OIL CONSERVATION COMMISSION

Re: Administrative Order

Administrative Order TX-21 ⁷⁵⁻²²

SHELL OIL CO.
 ANTELOPE RIDGE UNIT No. 2
 FINAL INSTALLATION DRAWING
 ANTELOPE RIDGE PENN. & DEVONIAN
 Sec. 4, T-24-S, R-34-E Lea Co., N.Mex.
 3-24-65

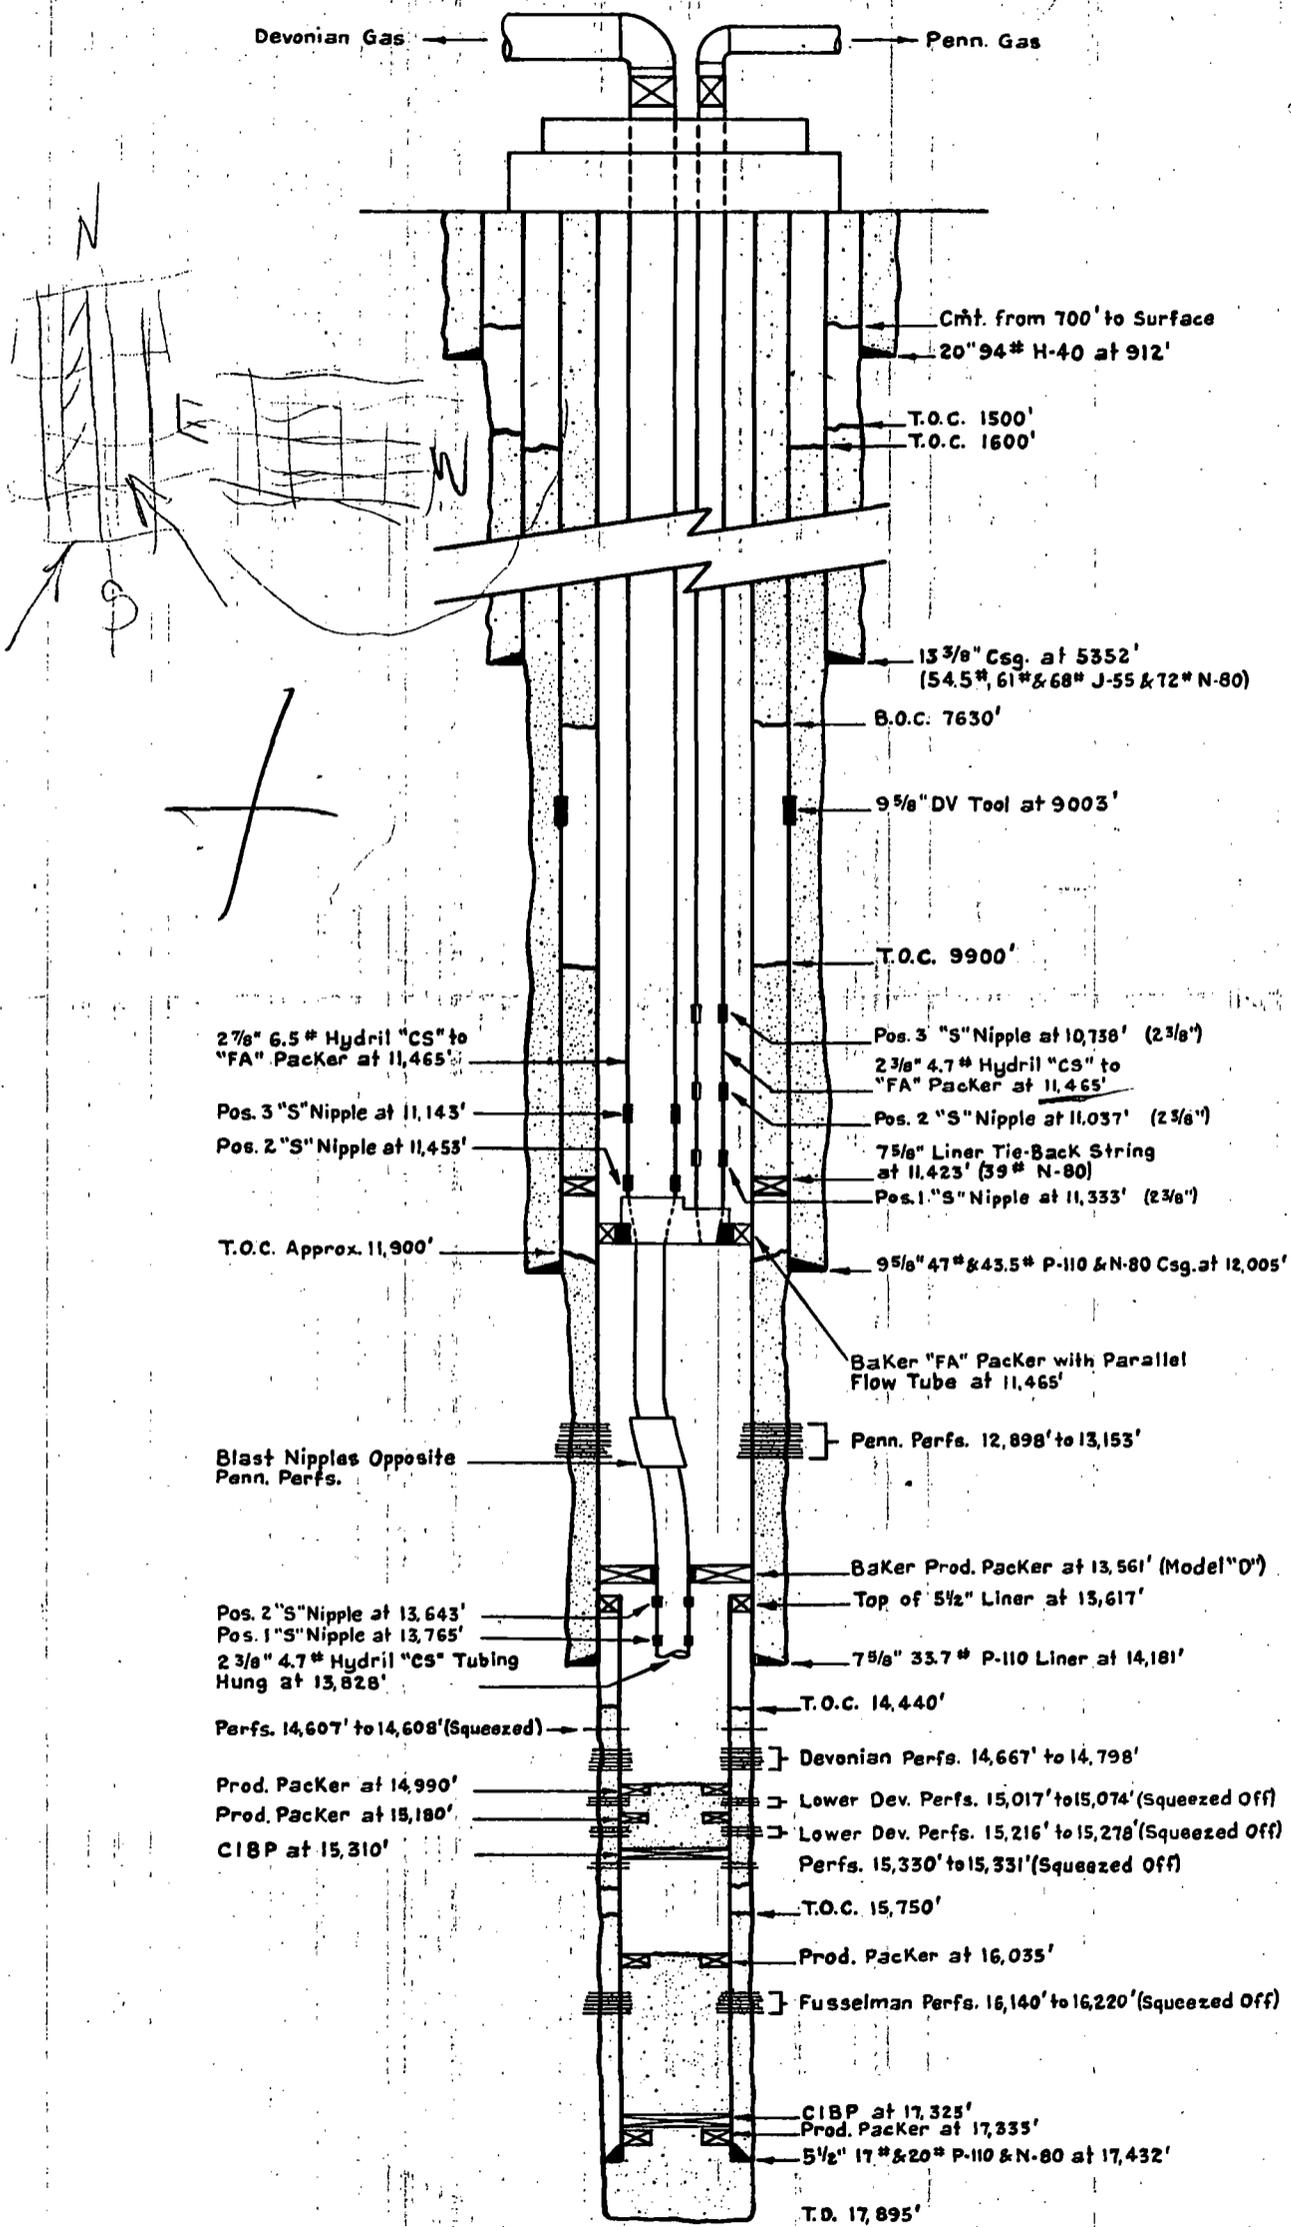
You will notice from the schematic diagram that the final mechanical installation differs from the installation submitted at the hearing in that the upper packer is set at 11,465' rather than at 12,780'. This difference occurred as a result of having to drill out heavy mud and lost circulation material in the 5 1/2-inch liner casing off the Devonian formation in order to complete in that zone, which in turn necessitated drilling out the production packers originally in place in the well. While setting replacement packers for the dual completion, the upper packer became stuck at 11,465' and had to be set at that point. Since drilling out the packers again would have incurred excessive costs, and would quite possibly have endangered the well from the standpoint of wearing "windows" in the production casing, we felt it prudent to proceed with the dual completion with the packers located as shown on the attached schematic diagram.

It is realized that the final mechanical installation shown on the attached diagram is not in accord with Statewide Rule 107(d)3. of the N.M.O.C.C. Rules and Regulations; however, in view of the circumstances and in accordance with Statewide Rule 107(d)4., we request an Administrative exception to the rule in this case. The gas produced from the upper zone is noncorrosive and will not endanger the exposed casing in any way. We feel that the final mechanical installation is consistent with good conservation practices and that no waste will be caused.

Y
Shell Oil Company is hereby authorized to complete the subject well in the aforesaid manner. The Oil Conservation Commission does however reserve the right to require some other method of completion in the event that this proves to be inefficient or wasteful.
